# City Of New London

### ADDENDUM # 1

Proposal No.: **2025-03 CONL**

**Briggs Brook and Fulton Park Improvements**

NOTE: DIMENSIONS OF BRIDGE BEARING LAYOUT SHALL BE SUBMITTED TO ENGINEER FOR REVIEW. THE BRIDGE SEAT DESIGN MAY NEED TO BE ALTERED TO ACCOMMODATE THE CHOSEN BRIDGE SYSTEM.

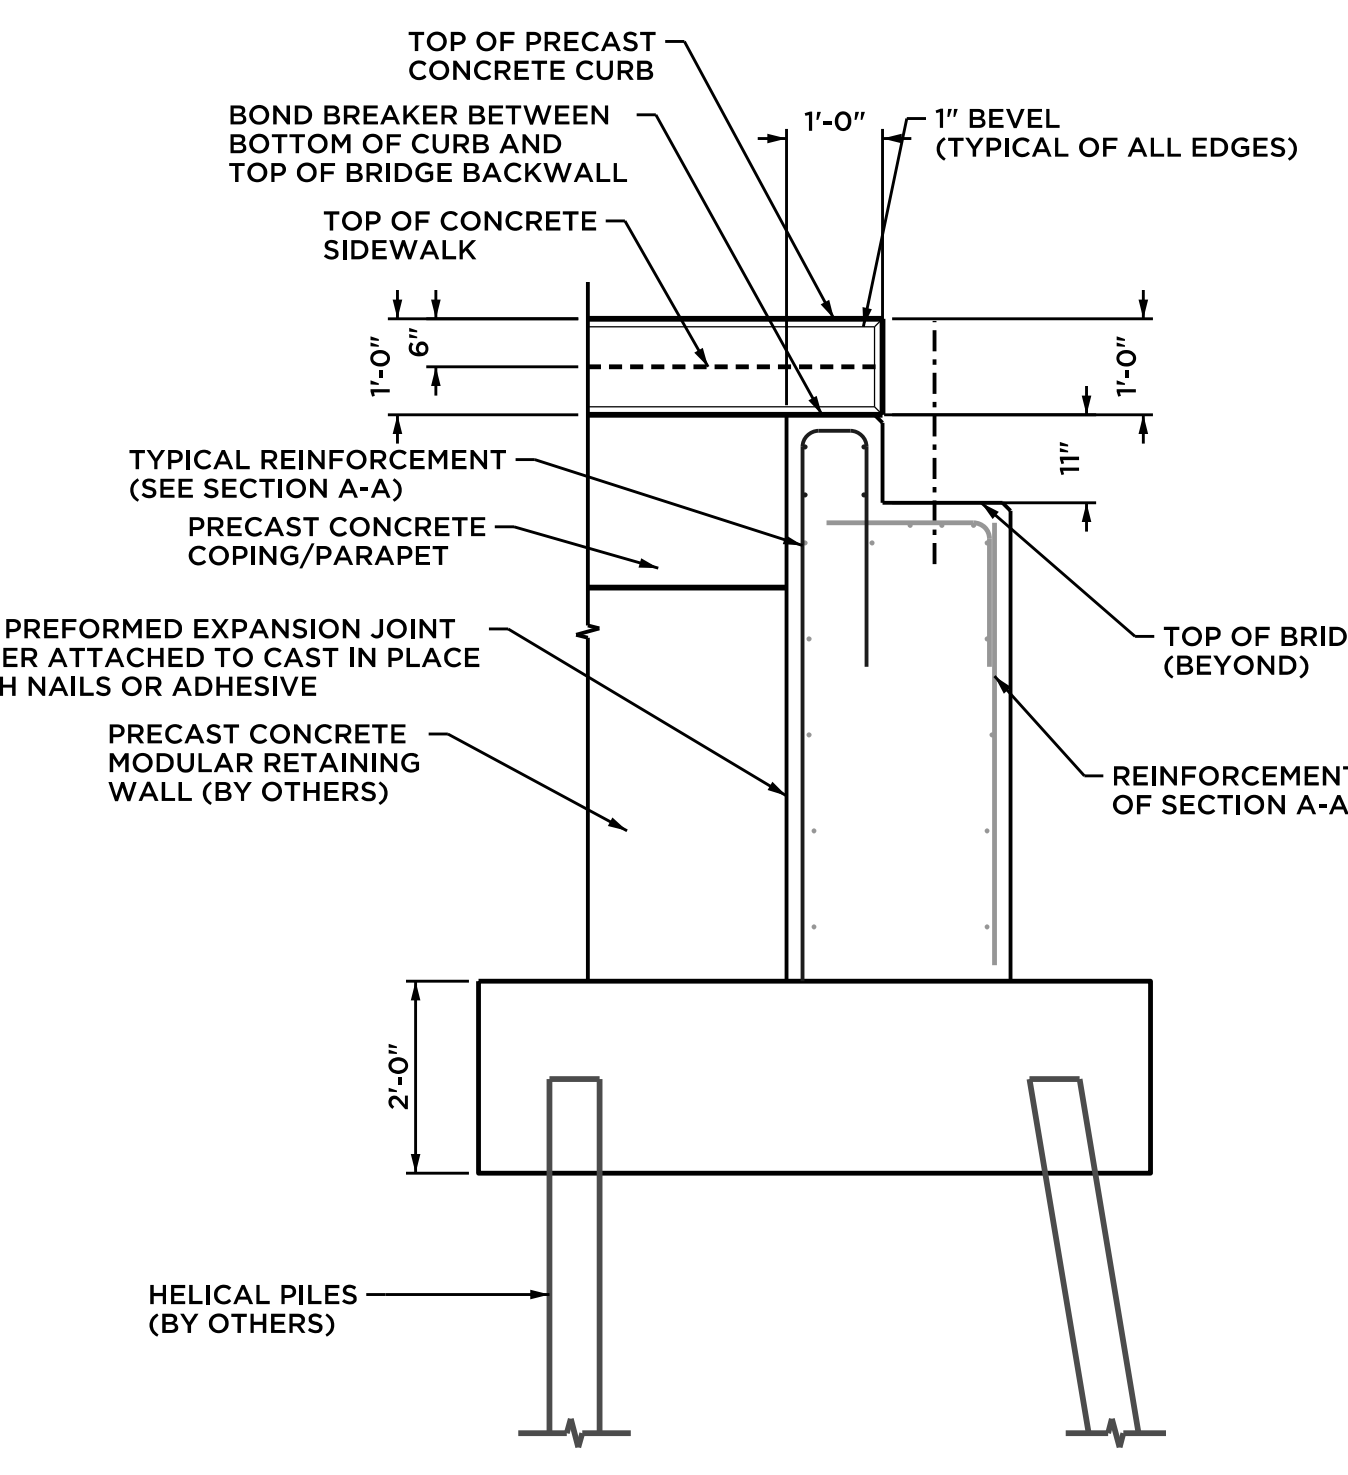
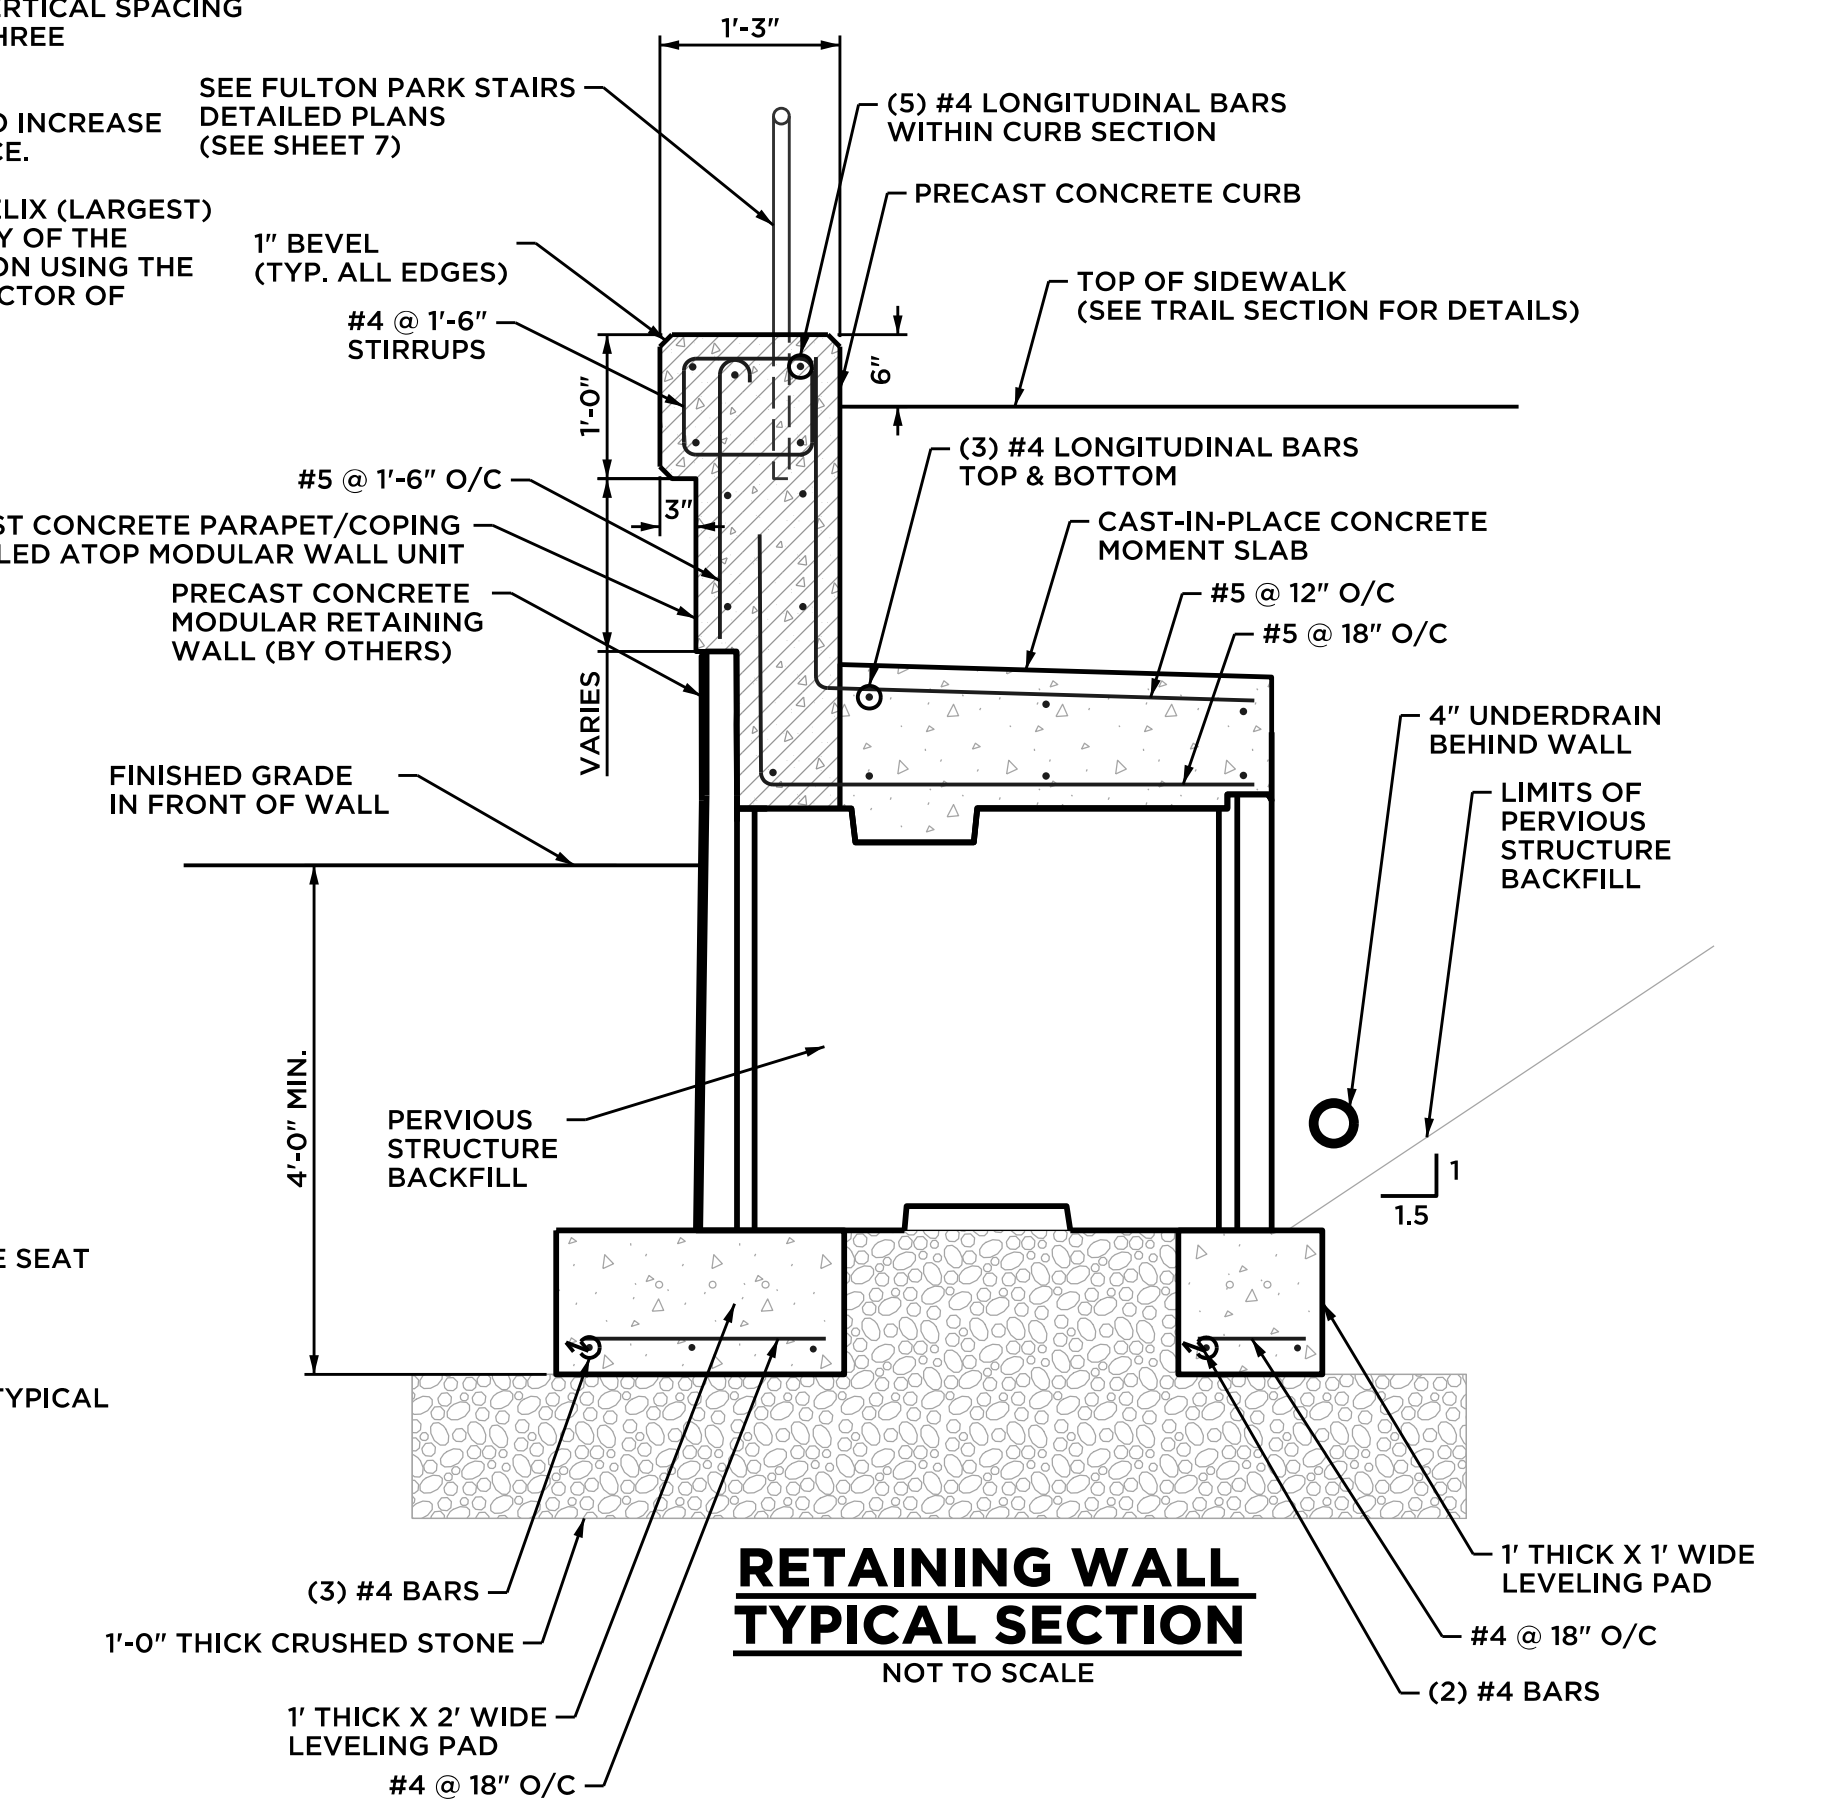
Q3. Specifications 31 66 15 2.1.2 call for sch 80 pipe 3.5" x 0.300" shaft, sheet 9 of 12 calls for 2.875" x 0.276" shaft. Should we follow the more stringent minimum?

Q4. Sheet 9 of 12 calls for a Carbide Rock It tip. This tip is available on square shaft leads. Please advise if the Carbide Rock It tip is required.

Q5. Sheet 9 of 12 note 3 calls for 10/12/14 helix configuration. Note 8 calls for a minimum 3d spacing of piles. Pile cap layout suggests a 3ft pile spacing. Should we assume pile configuration or pile spacing should be used?

*A3. Please refer to revised plans/specs/bid form attached.*

*A4. Please refer to revised plans/specs/bid form attached.*

*A5. Please refer to revised plans/specs/bid form attached.*

- PILE MATERIAL:  
PILE LEAD SECTIONS RS2875.276 TRIPLE HELIX (10/12/14)  
PILE EXTENSIONS RS2875.276 (5', 7', AND 10' LENGTHS)  
HARDENED PILE TIP CARBIDE ROCK-IT TIP
